UNITED STATES PATENT AND TRADEMARK OFFICE

APPLICATION NO.	FILING DATE	FIRST NAMED INVENTOR	ATTORNEY DOCKET NO.	CONFIRMATION NO.
10/066,926	02/04/2002	Michael Hahn	HAHN 3	4338
27964	7590	04/22/2004	EXAMINER	
HITT GAINES P.C. P.O. BOX 832570 RICHARDSON, TX 75083			MACCHIAROLO, PETER J	
			ART UNIT	PAPER NUMBER
			2879

DETAILED ACTION

Figure 2

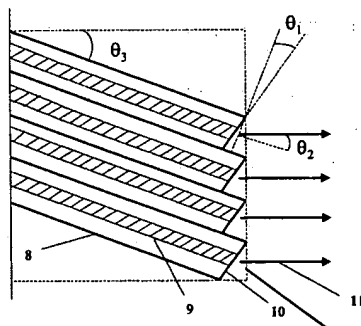
7. Claims 1, 6, 10, and 14 recite the electromagnetic energy is transmitted substantially normal to the waveguide array. However, the figures fail to show this configuration, but instead show the electromagnetic energy being transmitted askew to a transmitting face of the array, but normal to one of the dashed lines surrounding the array. Therefore, figure 2 leads the Examiner to believe that the dashed line is indeed the actual array with the substrates (8) being placed therein, as also inferred from the Summary of the Invention at page 3 of the instant Specification. “[A] substrate containing a plurality of substrate rows or layers.” If this is the case, the Examiner recommends adding a reference numeral to the dashed line to indicate the array such as illustrated below. Further, the claimed language, “normal to said waveguide array” is unclear. The Examiner reads, “normal to a transmitting face of said waveguide array.”

8. Further, claims 1 and 6 recite each of the optical fibers are “aligned at an offset angle.”

This is unclear. The Examiner reads, “aligned at an offset angle to a face of said waveguide array” as taught in Applicant’s figure 2 and page 3 of the instant Specification.

11. The refractive indices of the fiber optic cable and the waveguide array substrate are needed to calculate the refraction of the electromagnetic light at the fiber optic cable/waveguide array substrate interface, i.e. at the row face (fig. 2, 10), so the electromagnetic energy transmitted from each of the waveguide faces is substantially parallel to each other and substantially normal to a transmitting face of the waveguide array. However, instant specification and drawings are silent to these refractive indices, thereby not enabling one skilled in the art to properly make the array.
